From: Anita Gardner <Anita.Gardner@arun.gov.uk>
Sent: 25 February 2021 17:32
To: Planning.Responses <Planning.Responses@arun.gov.uk>
Subject: FW: Planning Consultation on: CM/53/20/PL
Importance: High

From: Kerry Simmons [REDACTED]
Sent: 25 February 2021 17:01
To: Anita Gardner <Anita.Gardner@arun.gov.uk>
Subject: RE: Planning Consultation on: CM/53/20/PL
Importance: High

From: Kerry Simmons [REDACTED]
Sent: 15 February 2021 14:54
To: Anita Gardner <Anita.Gardner@arun.gov.uk>
Subject: Planning Consultation on: CM/53/20/PL

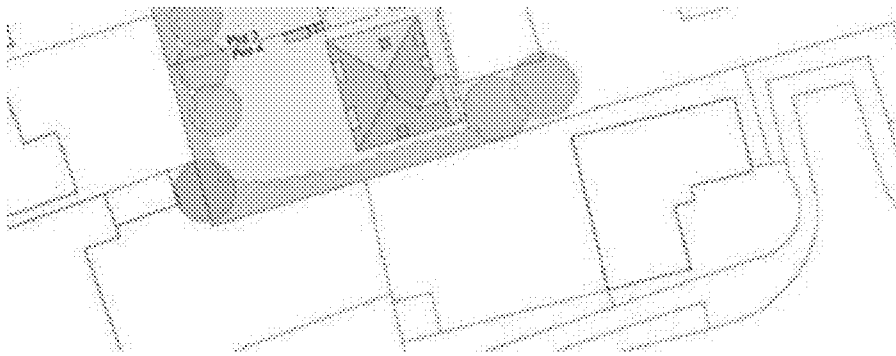
Without prejudice to the requested withdrawal of this application I would re-iterate that there are concerns regarding the proximity of the proposed dwelling at plot 4 to the side boundary with 30 Appletree Walk. The 45 degree rule is accepted as more relevant to an extension setting, but it serves to demonstrate that the outlook from rear windows is important and is a base for assessing these relationships. The Design Guide includes a section on backland development which is also relevant and states 'Backland developments should demonstrate an understanding of any potential effects on the character and amenities of the neighbouring urban area. As a general rule, backland developments should be subservient to existing properties, and their layout should seek to maximise the outlook of neighbours. Proposed building scales and development densities should address the characteristic urban development patterns of previous backland developments in the area.'

Plot 4 does not accord with this guidance. It cannot be described as maximising outlook or subservient given its height and proximity to the boundary. The gap to the boundary should be dimensioned and increased, or the height of the dwelling reduced adjacent to the boundary. In my view, although the garden to no 30 may receive an acceptable amount of sunlight/daylight from the south and west the dwelling would have an overbearing impact on the users of this garden since it extends to approximately half of the garden length.

Plot 4: we would like to clarify whether the 45 degree rule is strictly relevant to the relationship between plot 4 and the neighbouring property at 30 Apple Tree Walk; there would be a significant gap between the rear of no. 30 and the proposed house at plot 4 as shown on the extract site plan below. Our understanding of the 45 degree rule is that it applies where there the development would result in a continuous built form along the side of an existing dwelling, and is traditionally applied to assessing the impact of an extension on an existing dwelling. Due to the orientation of the properties no. 30 will continue to receive uninterrupted sunlight/daylight from the south and west as the proposed unit is positioned to the north and will also enjoy a large gap between its rear elevation and side elevation of plot 4. Based on this information it is considered that plot 4 would have an acceptable relationship with no. 30 Apple Tree Walk.

Would it be possible to have a quick chat about plot 4? We are looking to withdraw and redesign this plot – potentially to a meaningful 1.5 chalet style wot reduce the eaves on the boundary and move the side elevation off the boundary.
